RFT 21-159 – Interior Renovations and Ventilation Upgrades – Rolling Meadows PS

PAGE 1 OF 3
END OF ADDENDUM 1

**ADD#1
SK-01**

1 ENLARGED FLOOR PLAN - MAIN OFFICE (ROOM 100)
SK-01 SCALE: NTS

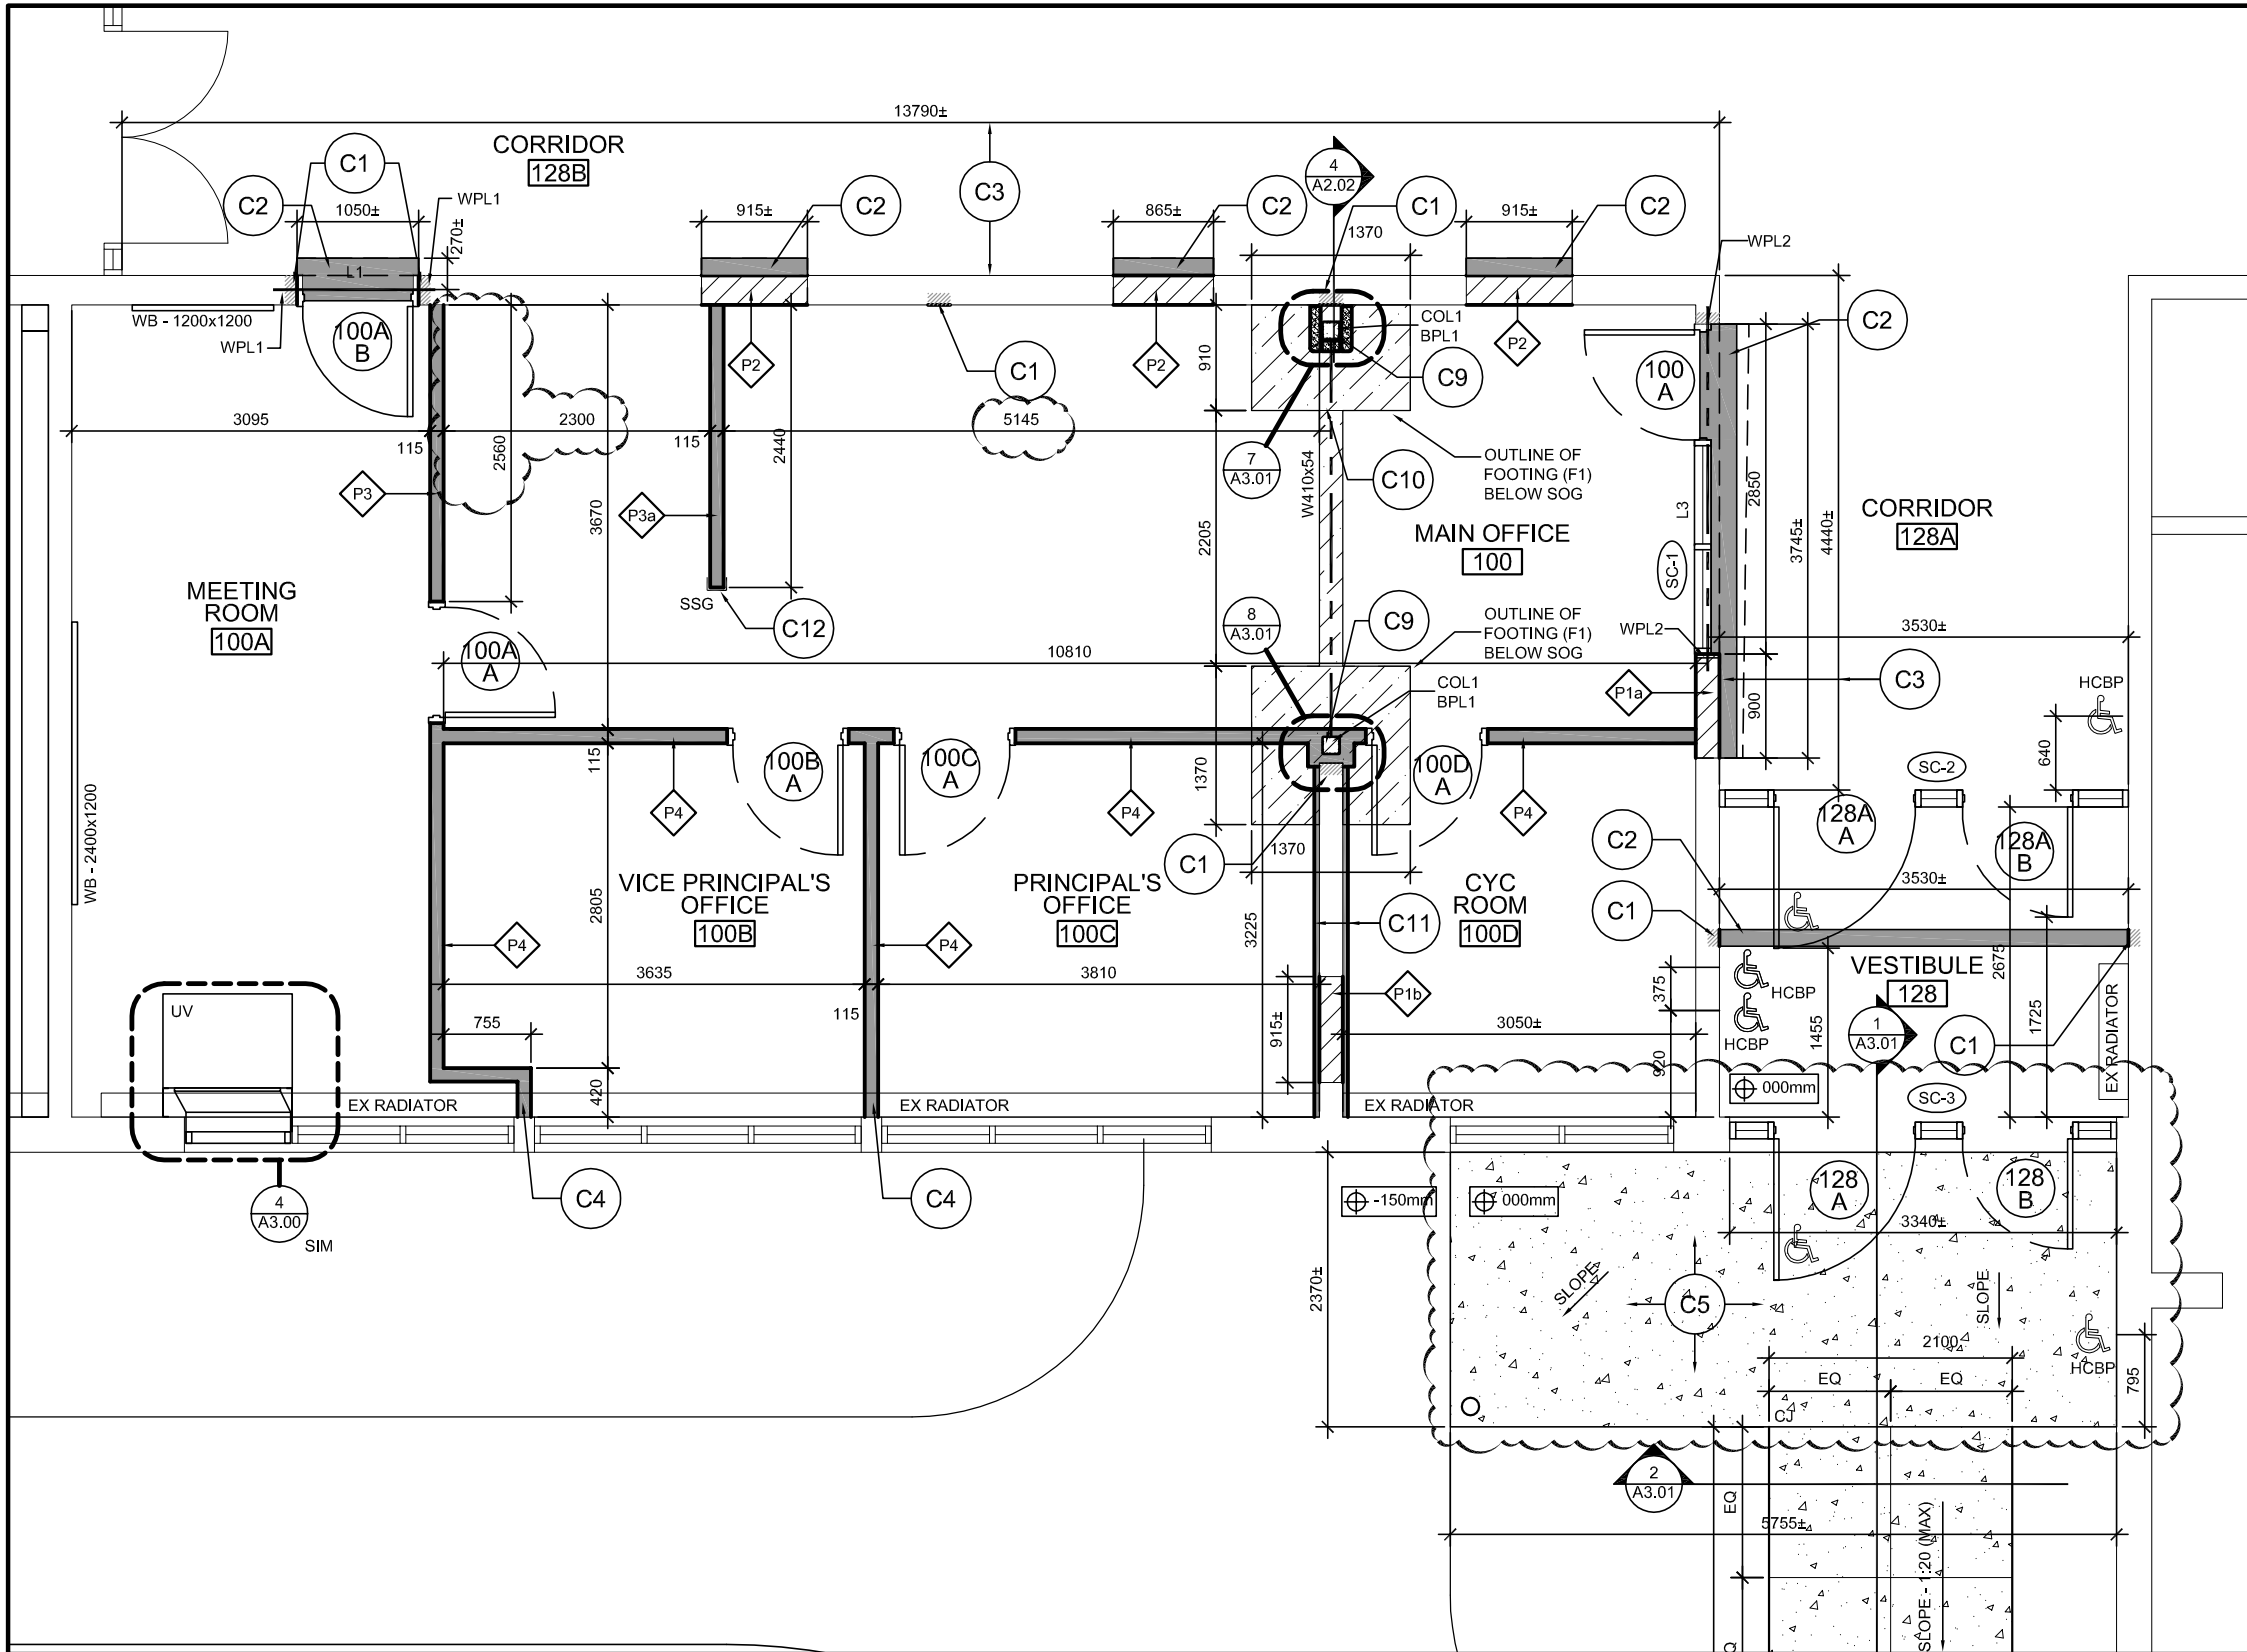
- Item 1** **Revision** - The layout of the main office (room 100) has been revised. Refer to attached sketch SK-01 for revisions.
- Item 2** **Revision** - The height of wall type P3a has been revised. The height of this wall type is to be 2000mm above finished floor.
- Item 3** **Addition** – Remove and dispose of existing precast concrete sills outside of doors 128 A and 128 B. Remove any remaining mortar and make surface ready to receive new concrete slab. Refer to sketch SK-01 for door location.
- Item 4** **Addition** – Remove and dispose of existing precast concrete pavers on existing concrete slab outside of door 128 A and 128 B. Make existing concrete slab ready to receive new concrete pad. Refer to SK-01 for location.
- Item 5** **Revision** – Base cabinet and upper cabinets MM-1 have been deleted from the main office (room 100)
